To/Attention	Neeti Paudel, P.Eng. Transportation Project Manager City of Ottawa	Date	August 16, 2023
From	David Hook, P.Eng.	Project No	124875
cc	Kevin Harper, MCIP, RPP Director, Infill Development Minto Communities - Canada		
Subject	178-200 Isabella Street – TIA Addendum #1

Although the TIA remains valid, refinements to the development concept have been made since the submission of the Final Report. The purpose of this TIA Addendum is to summarize the key changes from a transportation perspective and determine what impacts there may be on the conclusions/recommendations of the TIA, if any.

Appendix A – Updated Concept Plan

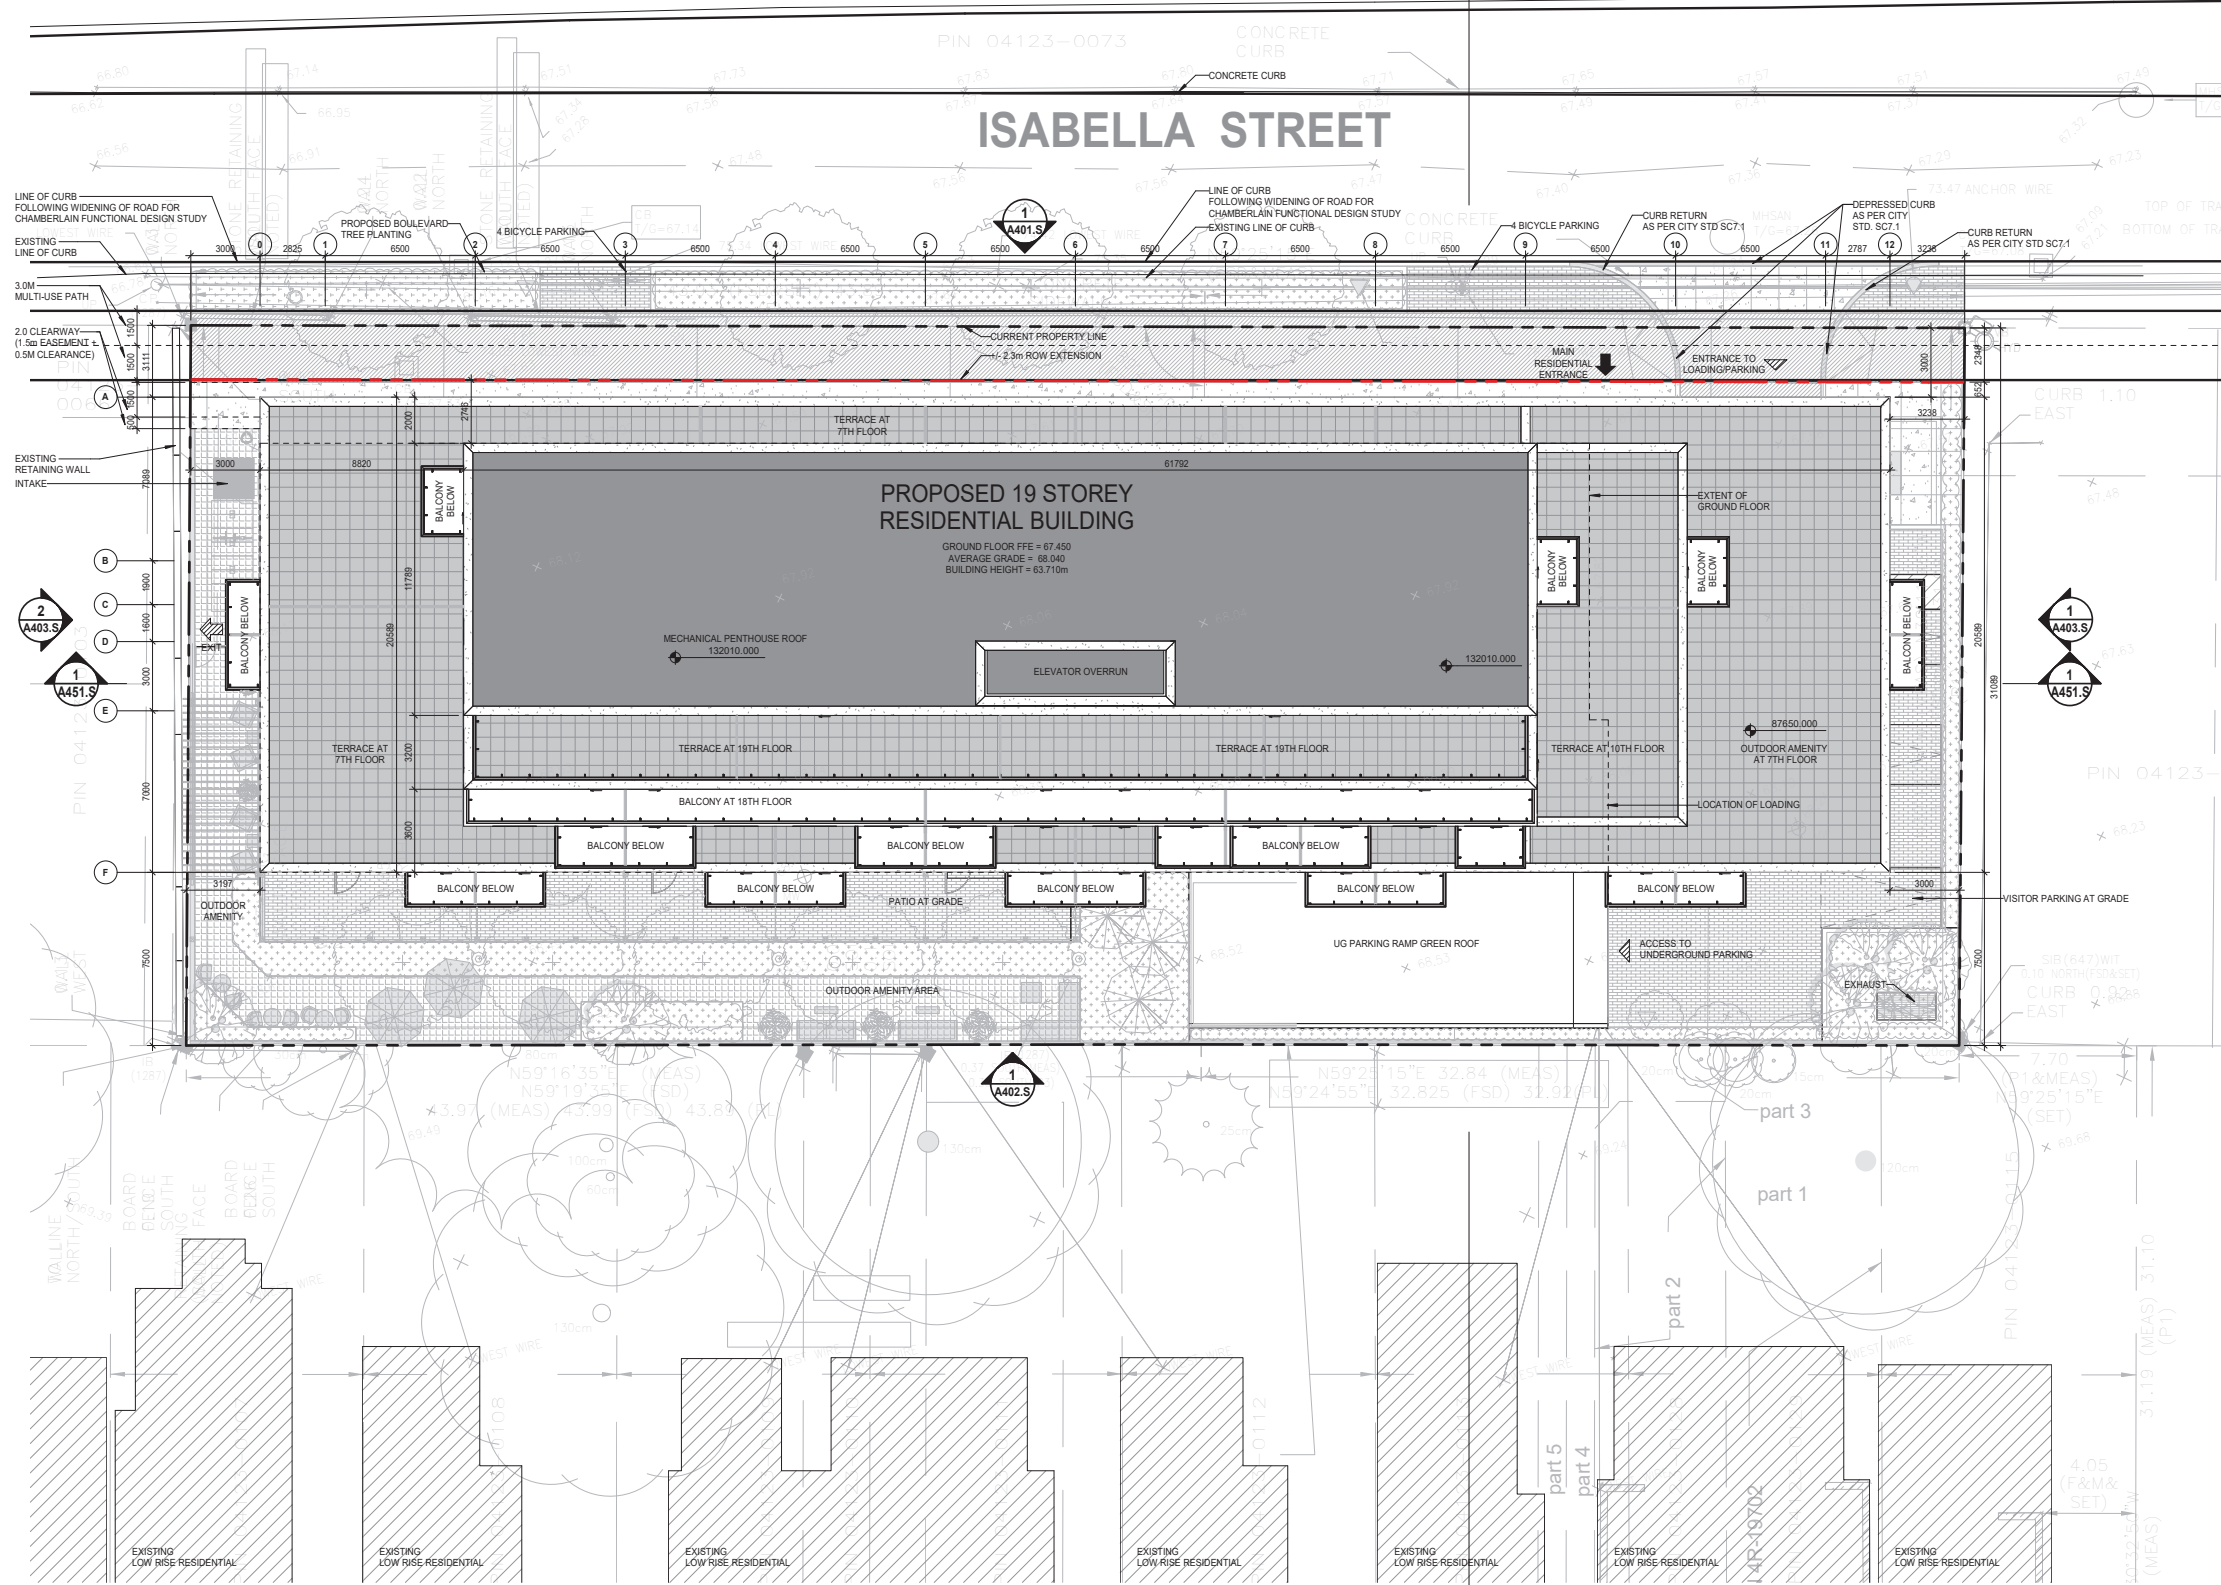
The revised concept plan is provided in **Appendix A**.

The changes in site statistics relative to the April 2021 TIA are summarized in **Table 1** below.

SITE STATISTICS	APRIL 2021 TIA	TIA ADDENDUM #1	CHANGE	COMMENTS
Dwelling Units	260 units	234 units	-26 units (-10%)	Slight reduction in unit count will lessen overall traffic impacts
Two-way Vehicle Trips ¹	84 vehicle trips ²	24 vehicle trips ³	-60 vehicle trips (-71%) ³	Per 'Revisions to 2023 TIA Guidelines', traffic modelling would no longer be required for a development generating <75 vehicle trips.
Vehicle Parking Spaces	175 spaces provided (149 spaces required)	132 spaces provided (122 spaces required)	-43 spaces (-25%)	Meets Zoning By-law (2008) requirements in both instances.
Bike Parking Spaces	262 spaces provided (131 spaces required)	242 spaces provided (117 spaces required)	-20 spaces (-7%)	Exceeds Zoning By-law (2008-250) requirement by at least two-fold in both instances.

To enhance the site frontage, an additional 0.5-metre buffer was also incorporated adjacent the protected 1.5m Pedestrian Easement to accommodate an additional clearance area from the building face to fixed objects such as planters and the opening of exterior doors, so as to not restrict path of travel for pedestrians.

Appendix C – Swept Path Analyses

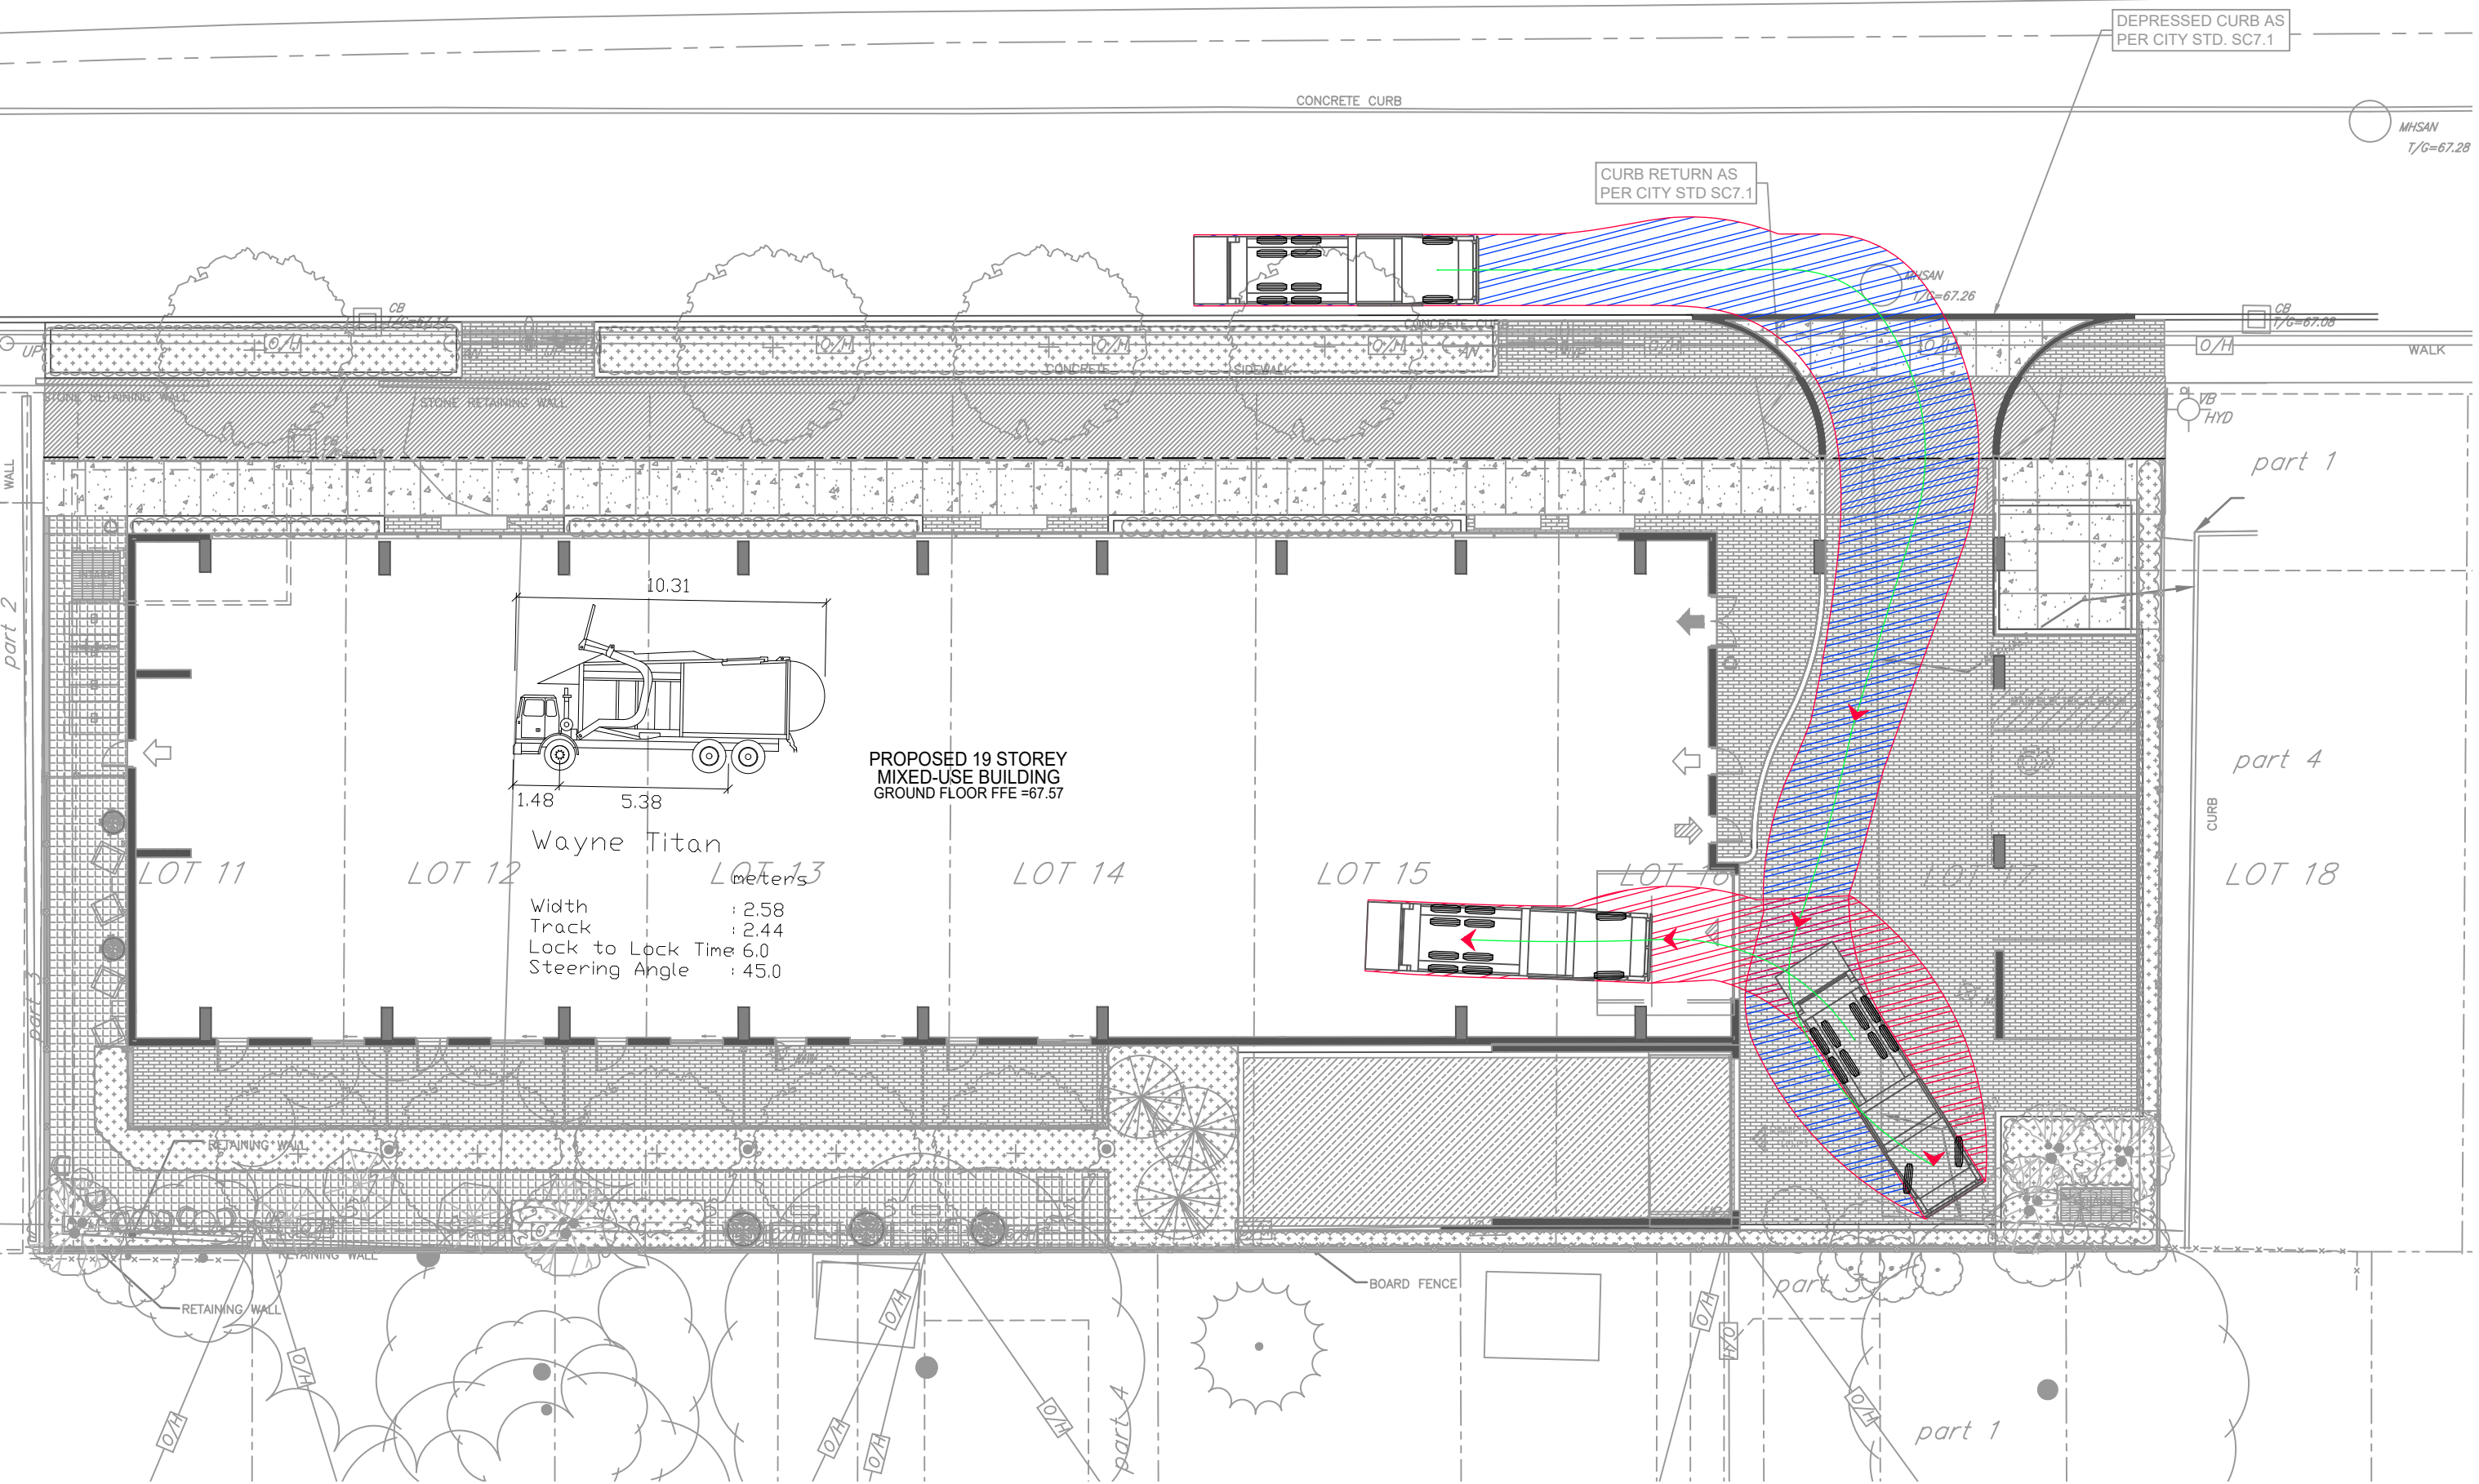
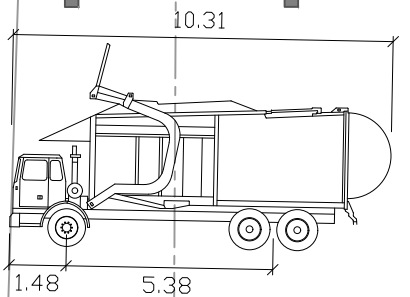
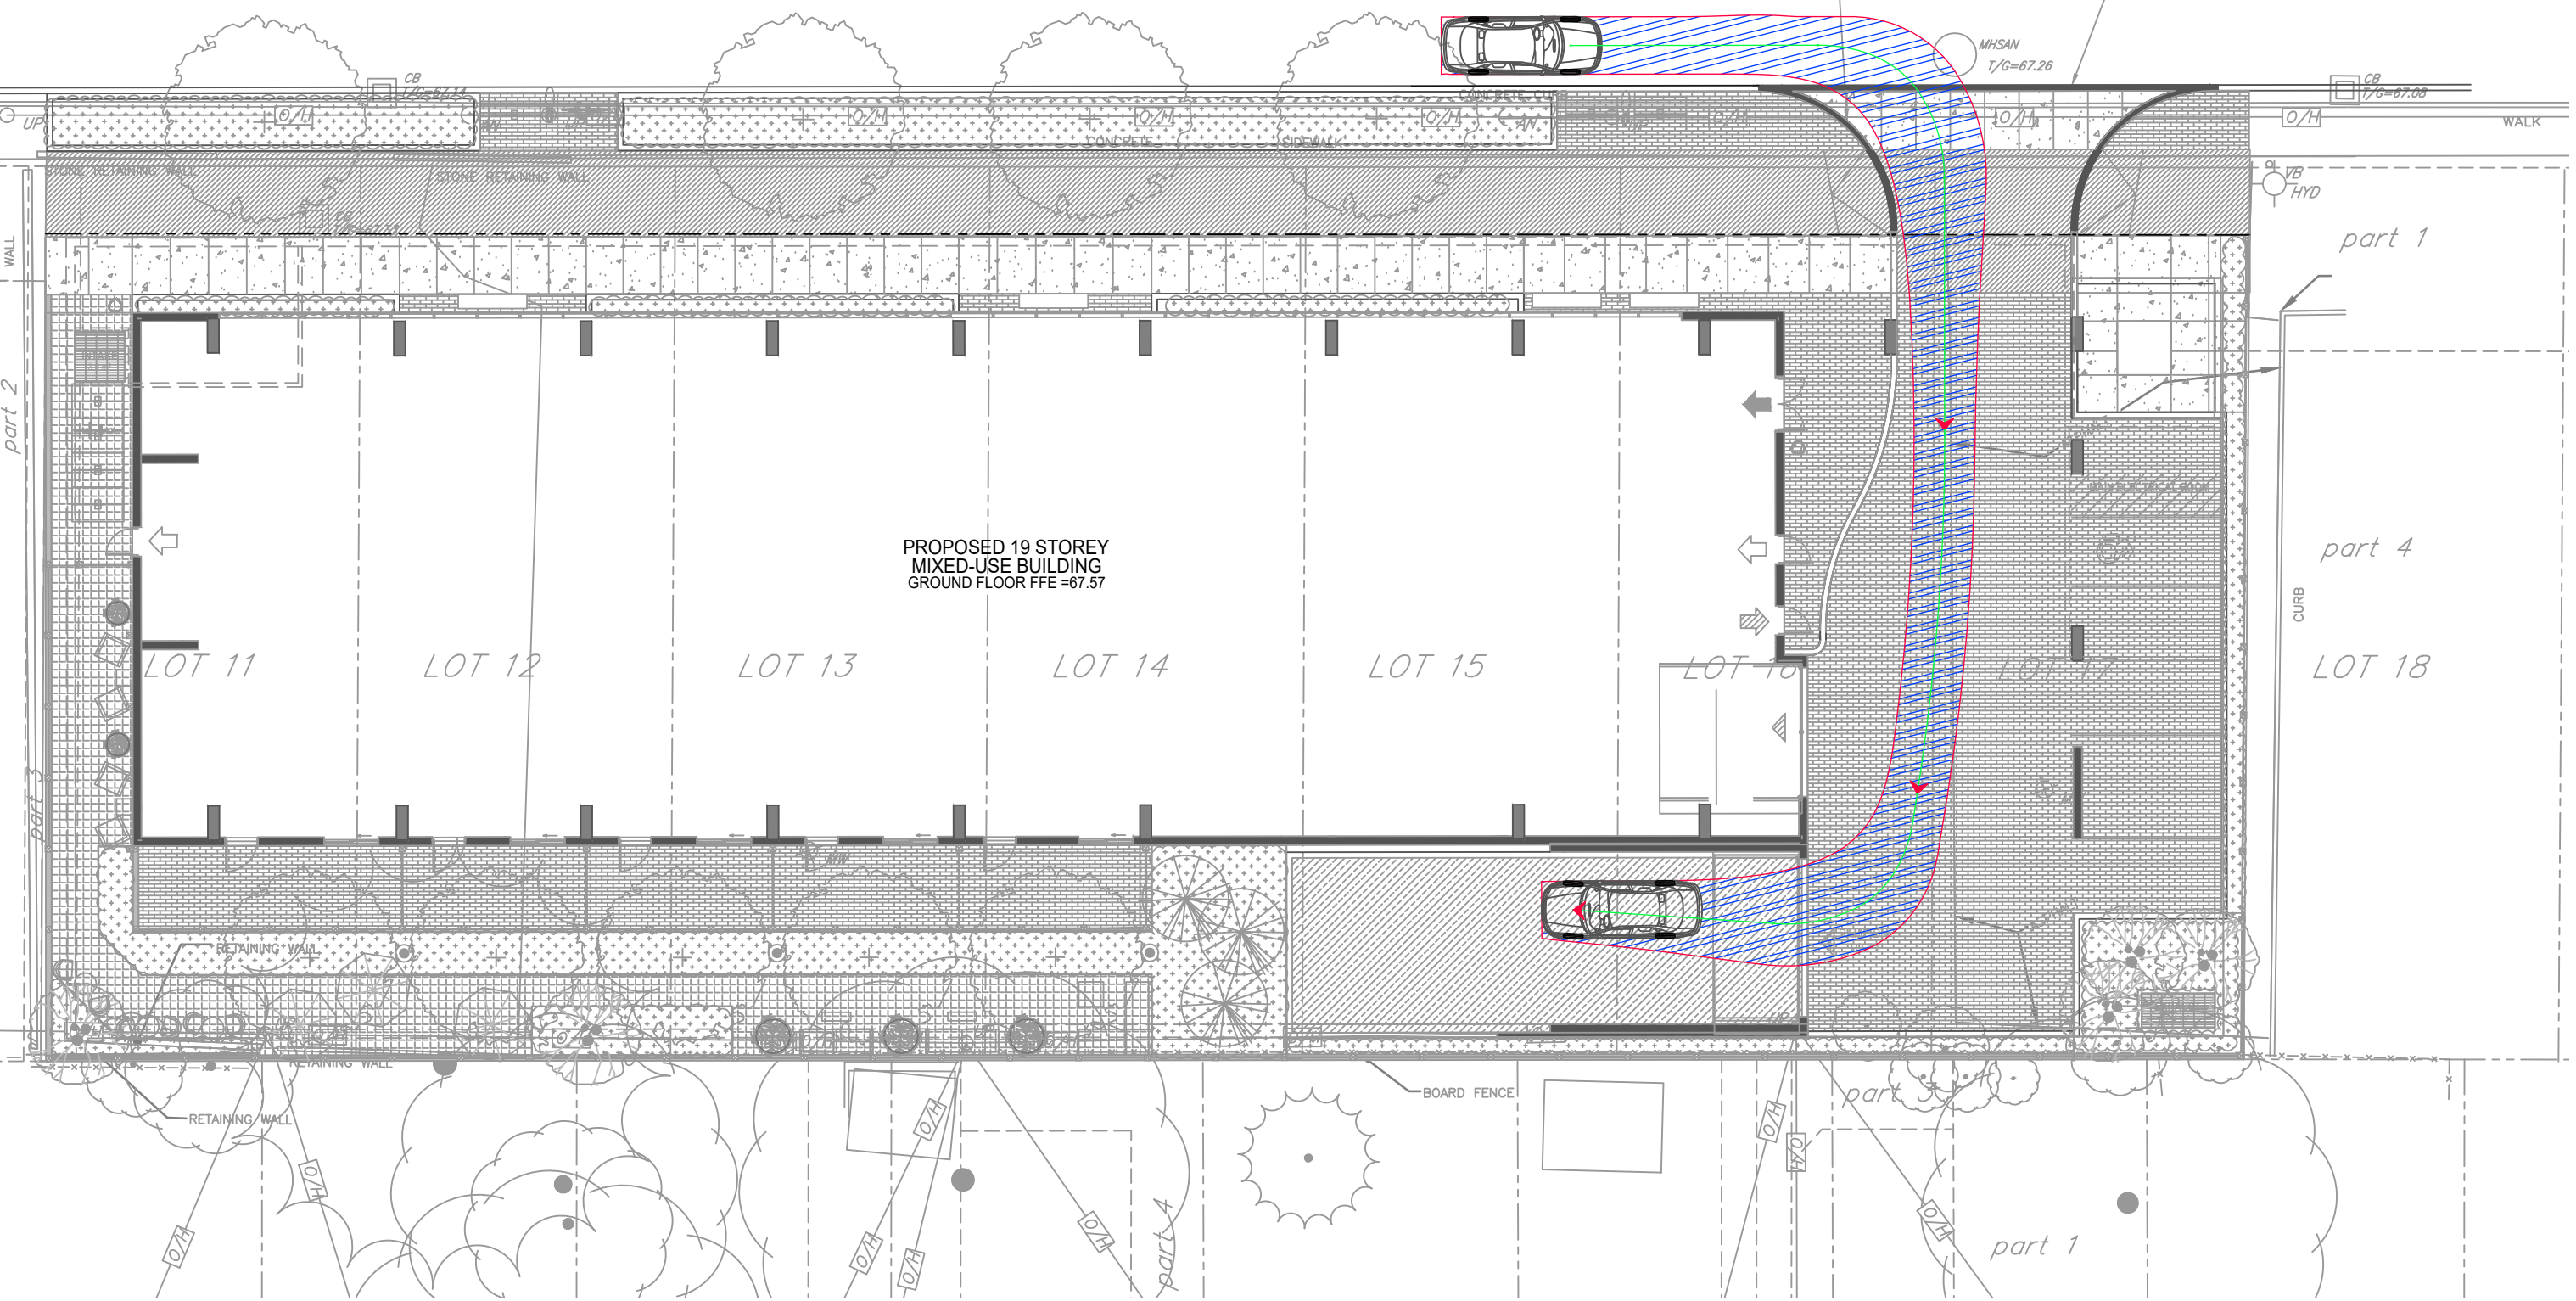
Turning templates conducted using AutoTURN swept path analysis software were revised to reflect minor updates to the concept plan since the April 2021 TIA Final Report. The analysis considered three (3) critical design vehicles: 1) Medium Single-Unit (MSU) Truck; 2) Front-loading Waste Collection Vehicle; and 3) TAC 1999 Passenger Car.

The results of the revised swept path analyses indicate that all three design vehicles noted above are able to successfully access and circulate through the site, as well as egress to Isabella Street in a forward motion without any encroachment issues with vertical sightline elements.

Updated turning template analyses are provided in **Appendix C**.
